***Design Review Board Case #2017-0006
Hoffman Town Center – Blocks 4 & 5***

Application	General Data	
Project Name: Hoffman Town Center Blocks 4 & 5 Location: 2410 and 2460 Mill Road Applicant: StonebridgeCarras	DRB Date:	January 18, 2018
	Site Area:	5.08 acres
	Zone:	CDD#2
	Proposed Use:	Residential, Retail
	Gross Floor Area:	1,051,048 sf
Purpose of Application:		
DRB Concept review of the Hoffman Town Center mixed-use retail and residential complex scheduled for public hearings in March 2018 (Stage 2).		
Staff Reviewers: Thomas H. Canfield, AIA tom.canfield@alexandriava.gov Robert Kerns, AICP, robert.kerns@alexandriava.gov Gary Wagner, RLA, gary.wagner@alexandriava.gov Nathan Imm, nathan.imm@alexandriava.gov Bill Cook, william.cook@alexandriava.gov		
<p>DRB ACTION, JANUARY 18, 2018: The DRB voted unanimously 5-0 to approve the architectural design with the direction that the Applicant work with staff on the following design refinements as conditions of the approval: 1) further study the Mill Road podium façade to adjust the pattern yet find resolution that is playful in character. This could include working with the mechanical openings, glass in the service corridor and subtle

Illustration 1: Example of Architecture Comment #1 and #2

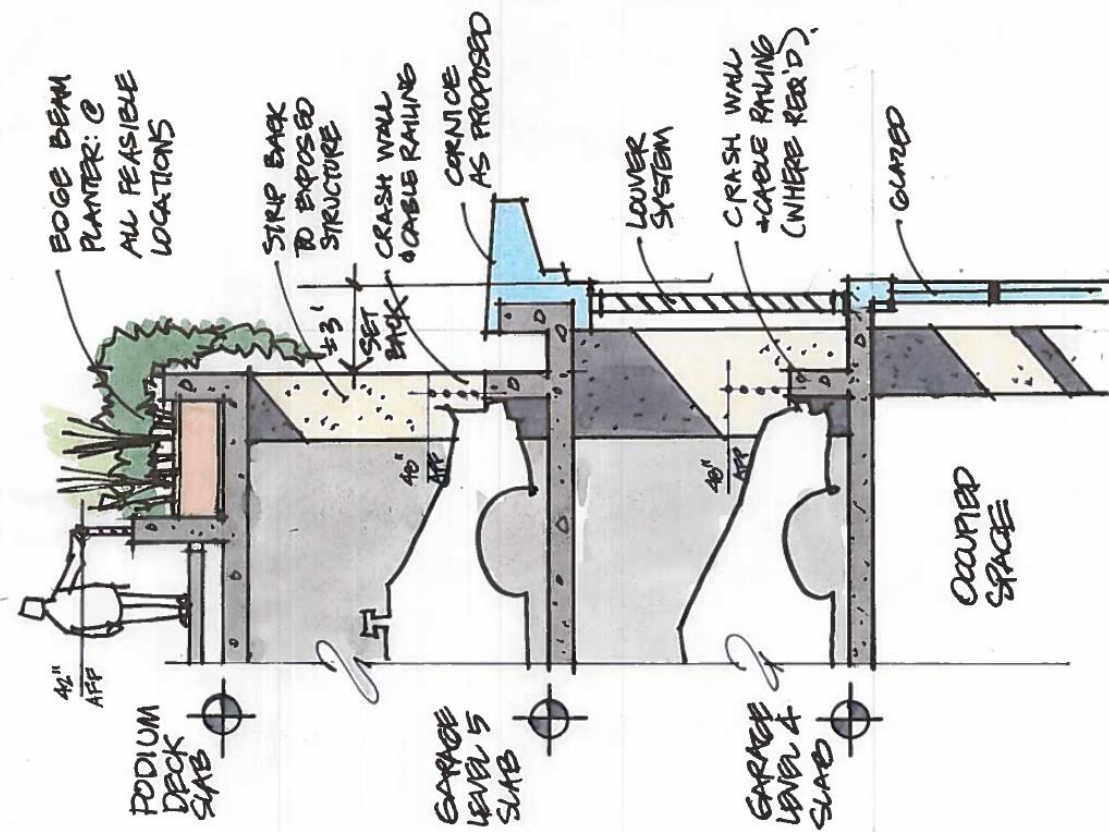
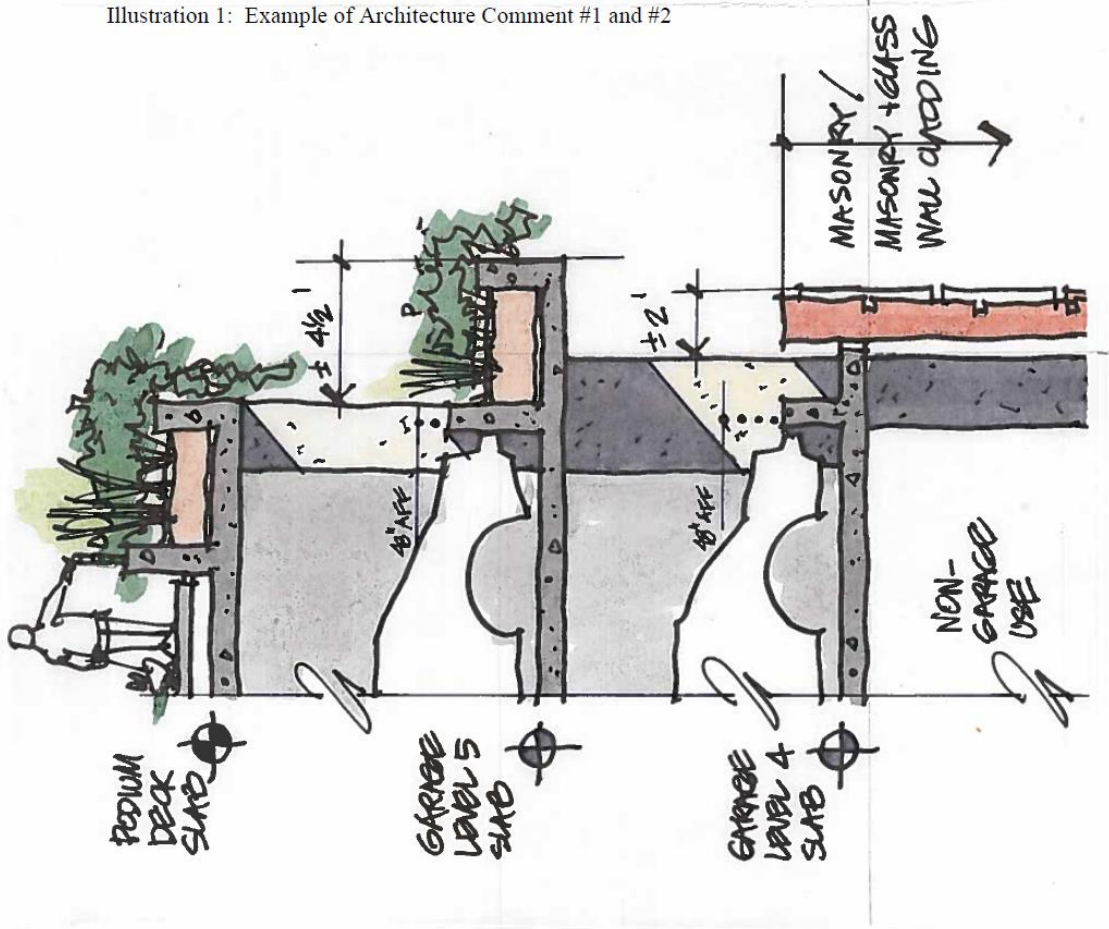
1. Garage 5th level and podium deck edge: (all sides, wherever possible) reduce perceived podium height by stripping off cladding, adding edge planter at podium deck, and pushing guardrail back, to reduce visibility of top level *and* provide a visual cue to the presence of the landscaped deck beyond. Wherever this can be achieved, it will also allow for increased air flow.

2. Garage link between Senior Living and Multifamily buildings: strip off cladding on Levels 4 and 5, as well as podium deck edge, using planter treatment as above, to create a stronger break between buildings. This may also be possible for much of the length of the blank façade currently shown along Mill and Stovall (both are “C: streets) in conjunction with 7) below, allowing reduction in visual bulk and improved garage ventilation.

Comment #1

Comment #2

Illustration 2: Example of Architecture Comment #1 and #2 and Landscape Comment #1

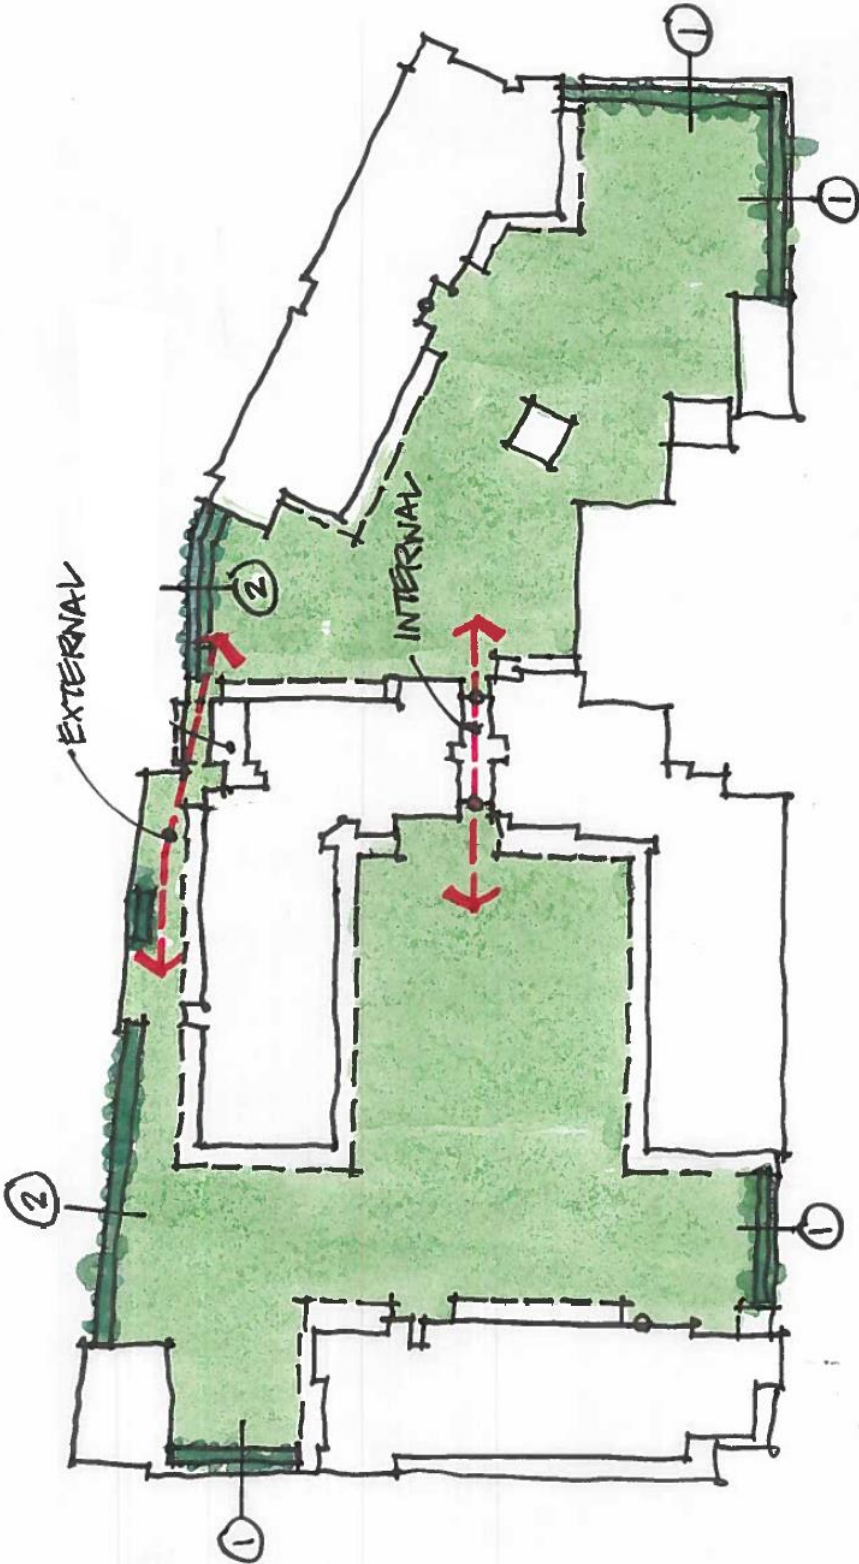
1. Develop a 24/7 pedestrian connection between the east and west portions of the landscaped podium deck; whether this connection is internal (through the Multifamily Building) or external (ex. along the north edge of the podium along Mill Road) it is important to allow all residents free access to the varied amenities such as dog parks and playground areas, distinct from the more private amenities proposed for each rooftop.

Illustration 3: Example of Architecture Comment #1 - #4, #6 - #8

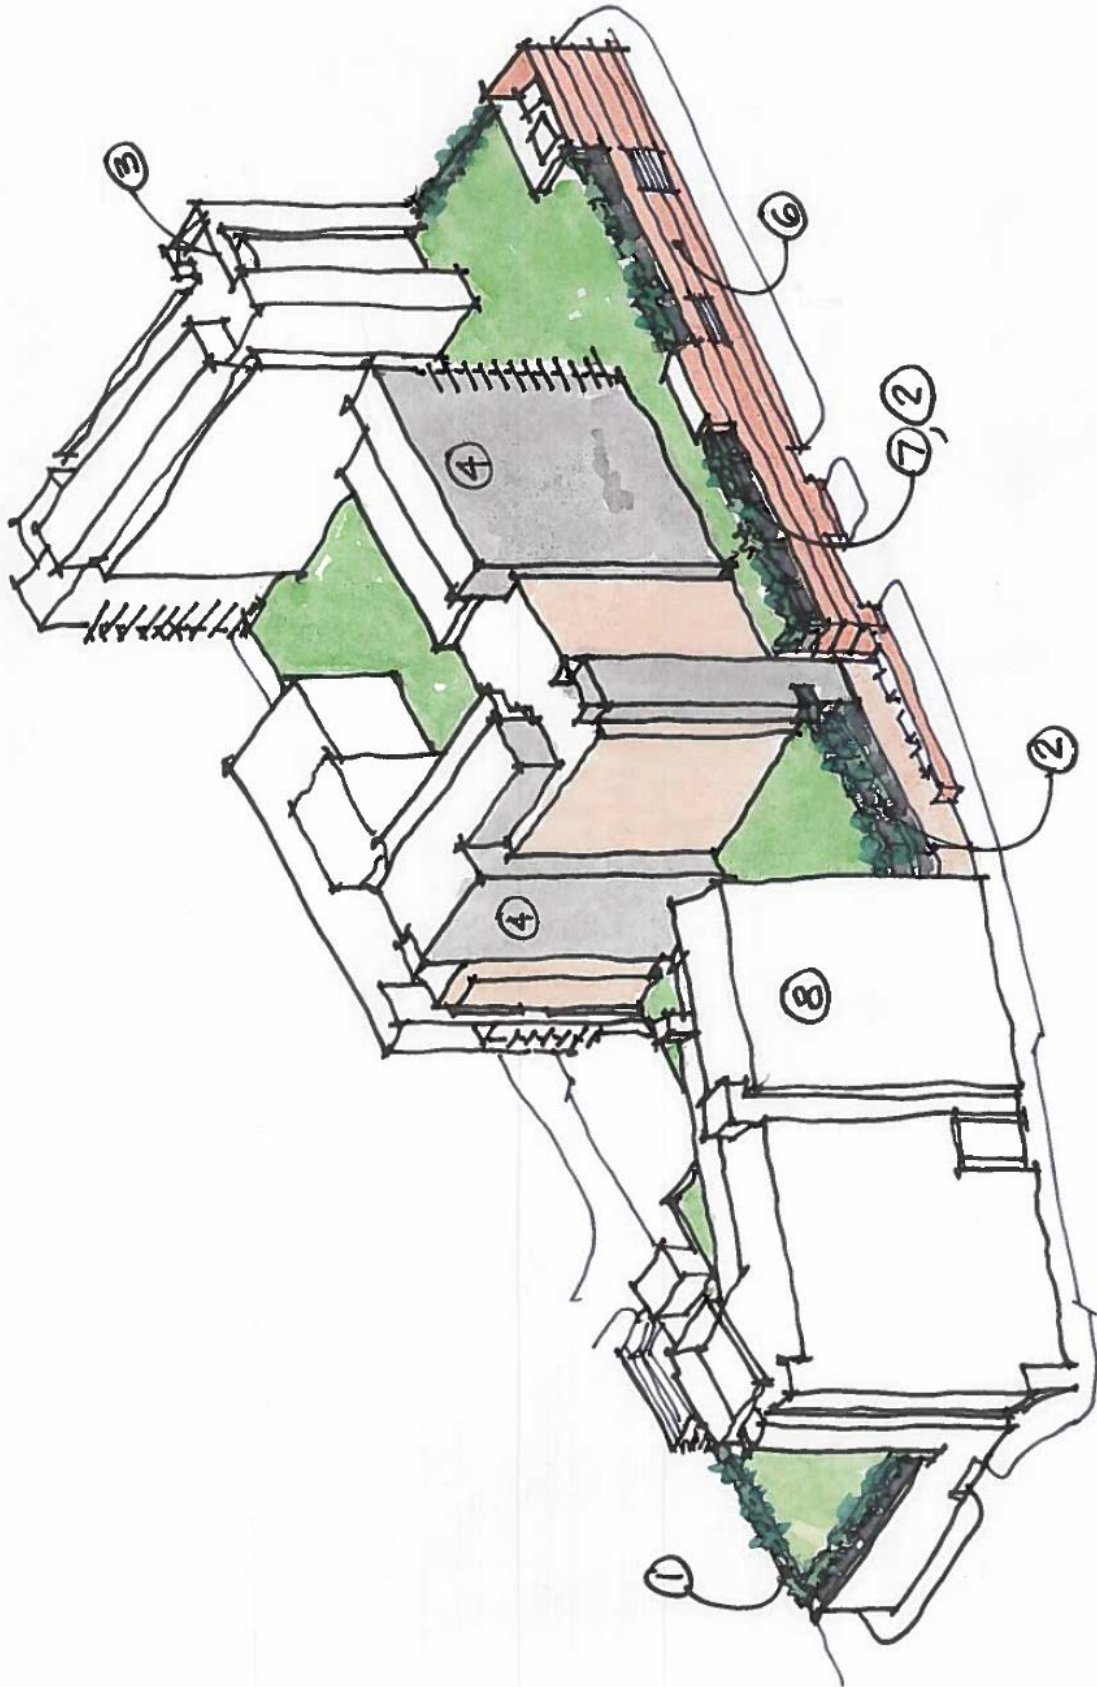
3. Condo Building: The alteration of the penthouse forms has created a “box-top” that distracts from the overall design of the buildings. As such, the north accent penthouse forms need additional refinement. Staff recommends that the Applicant study previous iterations and study connecting the two forms to create a stronger expression.

4. Multi-Family Building: stronger integration/expression of penthouse forms, through the use color and plane changes; delete slab-edge expression, which looks dated.

6. Simplify expression of screening wall along Mill and Stovall: the checkerboard pattern competes with tower architecture: this component of the complex should be a strong, simple background element, and needs to be coordinated with MEP ventilation requirements; also study strategies to reduce its physical bulk, as in 1) and 2) above.

7. In conjunction with 2) above, study the elimination of the Condominium service corridor currently shown on Parking Level 5, in favor of integration with the required service corridor on Level 1, which can connect directly to the Condominium vertical core

8. Senior Living Building: façade rhythmic organization should be simplified/clarified; scale/color of glazing subdivisions needs refinement – gridded glazing does not currently read strongly.
